Hotline Fix – ZM37-001

Clunk/click noise occurs from steering rack on Outlander / Outlander PHEV.

TSL2402006-D

ZM Outlander and ZM Outlander PHEV.

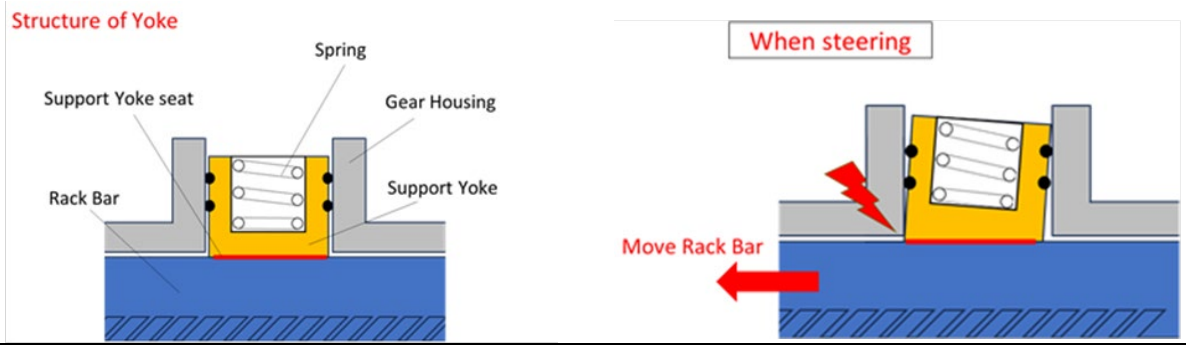
Complaint 1
If the grease between the rack and the support yoke seat becomes too thin, friction increases. When the steering wheel is turned, the support yoke may move and contact the rack housing. This may cause a clunk noise and vibration. Due to the design, the noise may not be completely eliminated.

Complaint 2
The crimping load of the assist side yoke plug may be insufficient.. As the steering components move during steering, the plug can also move slightly and create a clicking noise.

The grease between the rack bar and support yoke has been changed from:

On a customer complaint basis, replace the steering rack with the new one according to the workshop manual procedure.

The steering rack includes the EPS-ECU. Therefore, it is necessary to perform the programming then auto configuration of the EPS-ECU and the calibration of the steering torque sensor, according to the workshop manual.
